STAFF RECOMMENDATION
1816 5th Avenue North
January 15, 2014

Application: New construction-infill and outbuilding
District: Salemtown Neighborhood Conservation Zoning Overlay
Council District: 19
Map and Parcel Number: 08108027400
Applicant: Robin York, Red Group LLC
Project Lead: Sean Alexander, sean.alexander@nashville.gov

<p>Description of Project: Application is to construct a two-story duplex and a detached outbuilding on a vacant lot.</p> <p>Recommendation Summary: Staff recommends approval of the duplex infill and outbuilding with the following conditions:</p> <ul style="list-style-type: none">• The height of the roof is lowered to thirty-three feet (33') by lowering the pitch of the roof;• The house be pushed back on the lot to align with the house next door at 1814 5th Avenue North;• Staff review and approve the roof color and the materials for the porch columns, porch floor, and foundation;• Staff review and approve all window and door selections prior to purchase and installation;• Staff review and approve the materials of the outbuilding;• The HVAC unit be placed at the rear, or on a side façade beyond the midpoint of the house. <p>With these conditions, staff finds th

Layout Plan For:
1816 5th Avenue North
Nashville, TN 37208

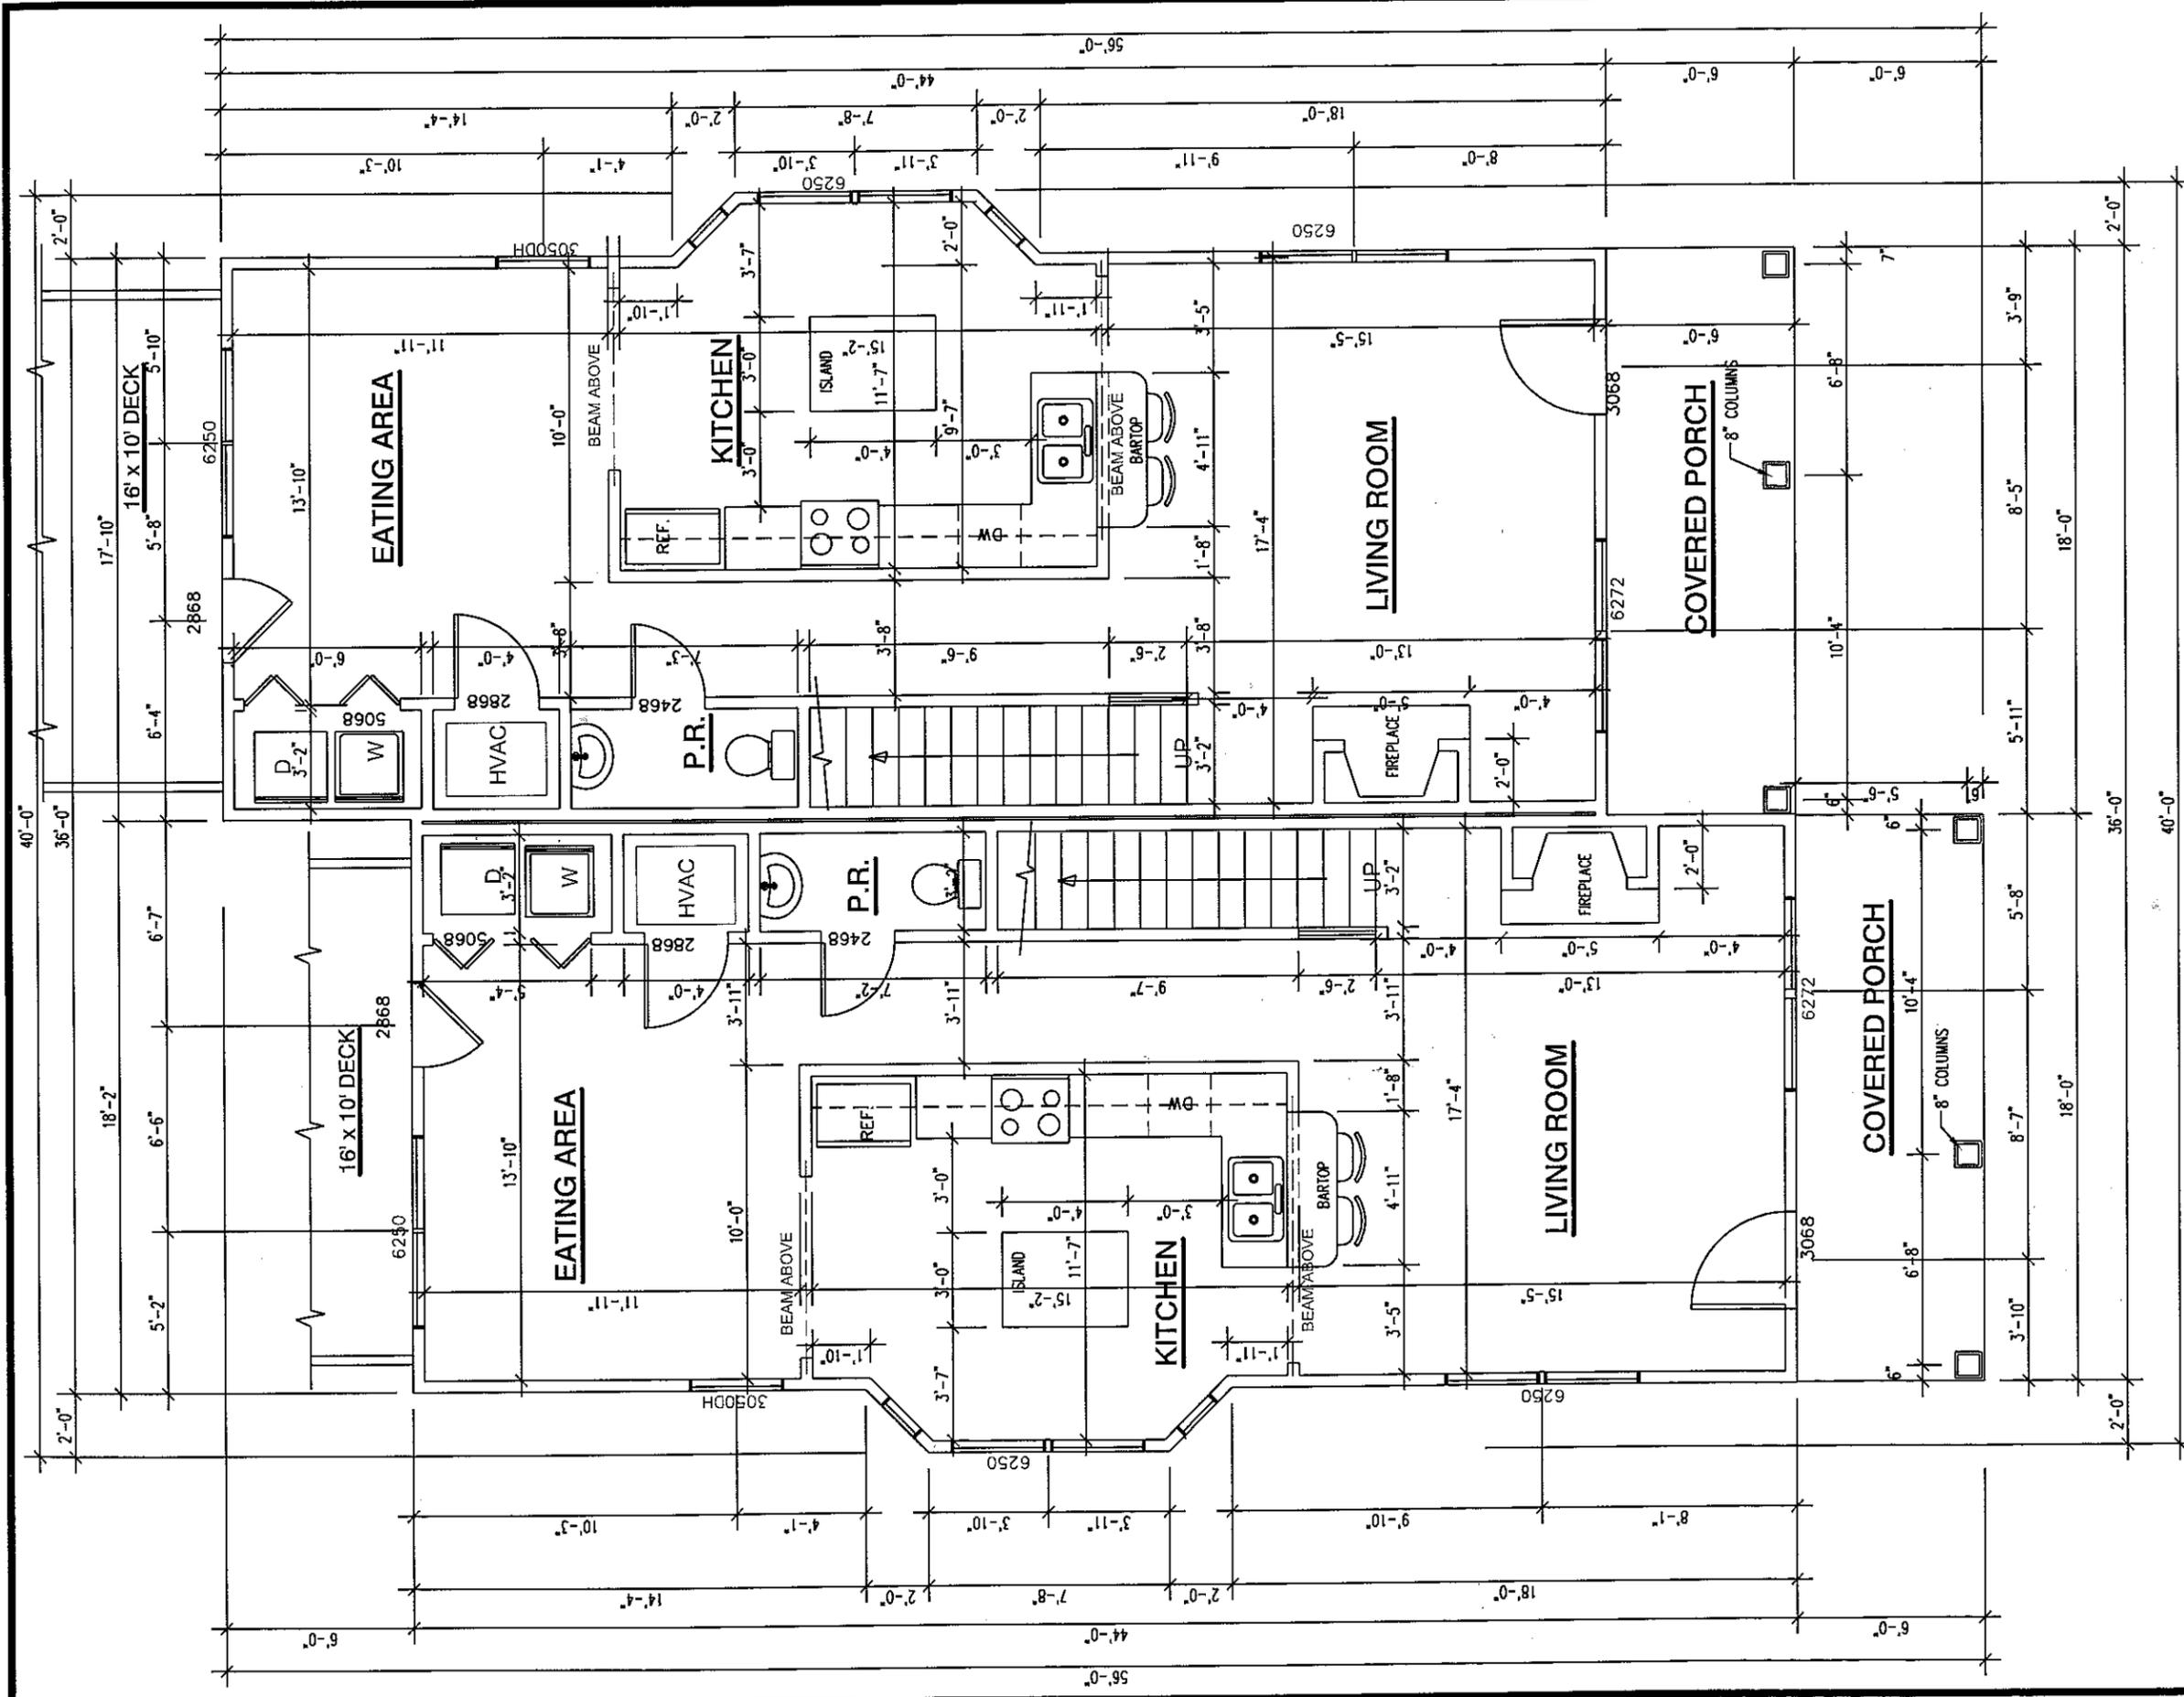
The proposed infill will be centered on the lot and will meet all base zoning setbacks. At the front, the structure will be seven feet (7') from each of the side property lines, although further back, the width of the structure expands so that it is five feet (5') from the side property lines. This allows for a more appropriate rhythm along the street, while allowing for larger units.

The front porch on the left side will be twenty feet (20') from the front property line. By comparison, the one-story historic structure at 1814 5th Avenue North is twenty-two feet (22') from the front property line. Staff recommends that the new infill have a front setback matching the adjacent structure. With the adjustment of the front setback, staff finds that the duplex's setback and rhythm of spacing meet Section III.C. of the *Salemtown Neighborhood Conservation Zoning Overlay: Handbook & Design Guidelines*.

- The height of the roof is lowered to thirty-three feet (33') by lowering the pitch of the roof;
- The house be pushed back on the lot to align with the house next door at 1814 5th Avenue North;
- Staff review and approve the roof color and the materials for the porch columns, porch floor, and foundation;
- Staff review and approve all window and door selections prior to purchase and installation;
- Staff review and approve the materials of the outbuilding;
- The HVAC unit be placed at the rear, or on a side façade beyond the midpoint of the house.

RIGHT SIDE ELEVATION

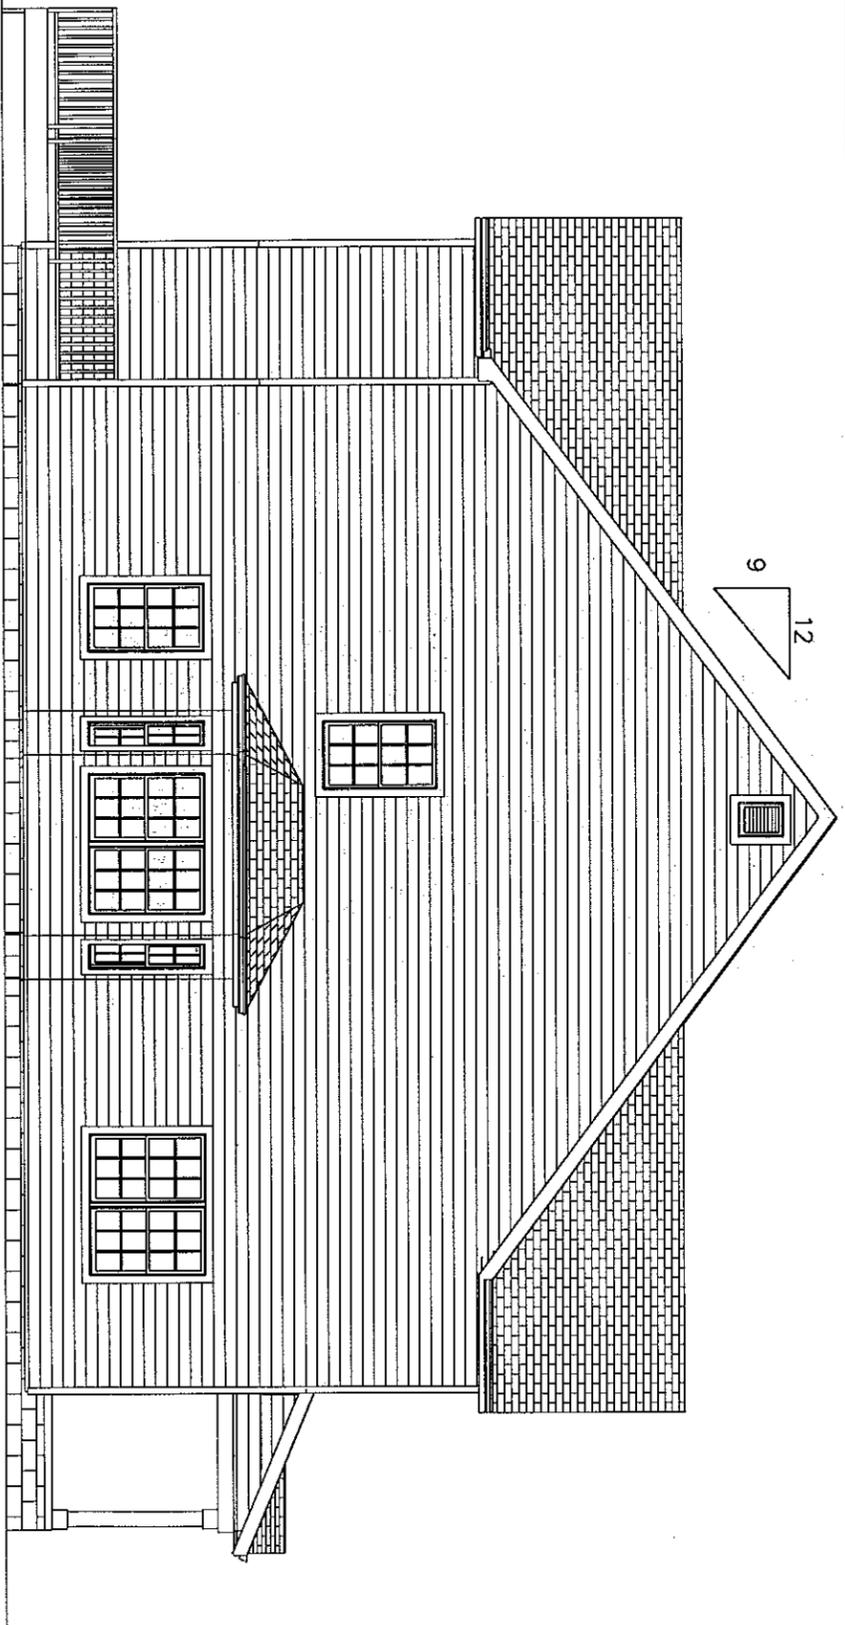
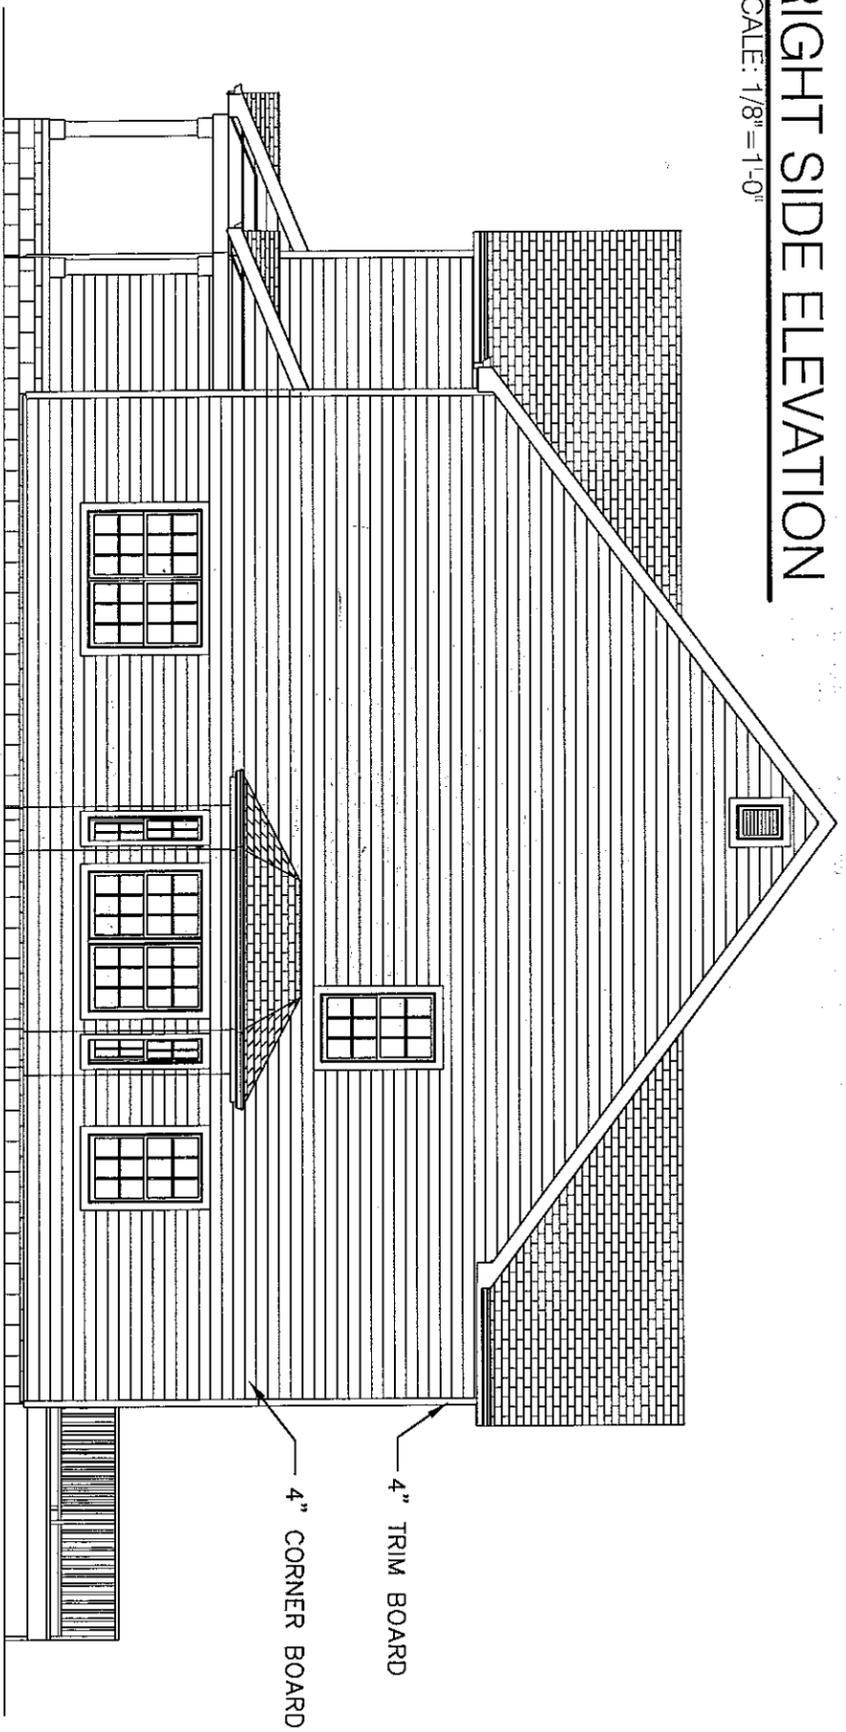
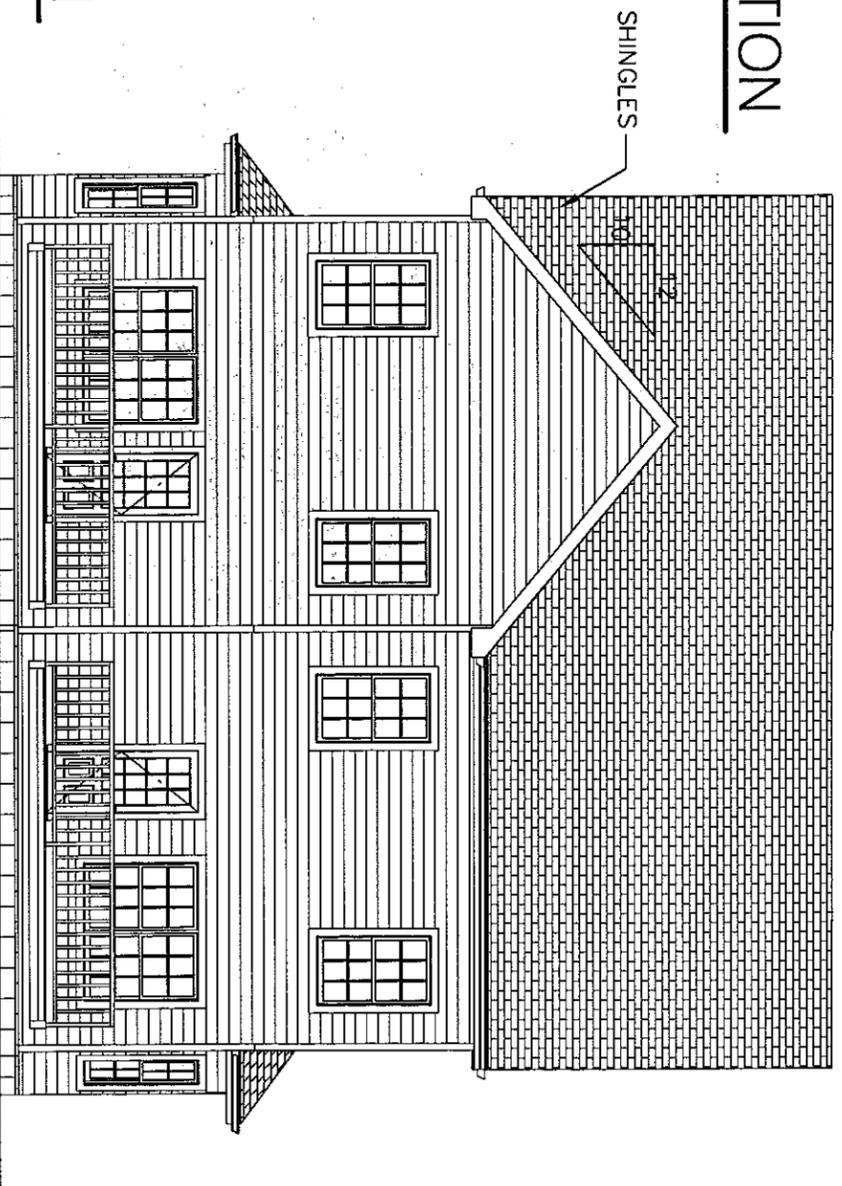
The new building will be thirty-six feet (36') tall with eaves at twenty feet (20') above grade. There will be one foot (1') of foundation exposed, and the finished floor level will be two feet (2') above grade. By comparison, the houses in the immediate vicinity have heights that range from eighteen feet (18') to thirty-three feet (33'). At its current height, Staff finds that the height of the new building would be incompatible with surrounding historic houses.

Roof form: The house's primary roof form will be a gabled-ell. The primary side-facing gable will have a pitch of 9:12 and the front gable will have a pitch of 10:12. Lowering the primary roof pitch to 7:12, which the applicant has already agreed to, will result in a more appropriate height for the building, and will be more compatible with the roofs of historic houses in the vicinity. Both front porches will have shed roofs with a slope of 5:12. With the reduction of the primary roof pitch, Staff finds that the duplex's roof forms meet Section III.E. of the *Salemtown Neighborhood Conservation Zoning Overlay: Handbook & Design Guidelines*.

The height of the building should be reduced to a maximum of thirty-three feet (33') to meet Section III.A. of the *Salemtown Neighborhood Conservation Zoning Overlay: Handbook & Design Guidelines*.
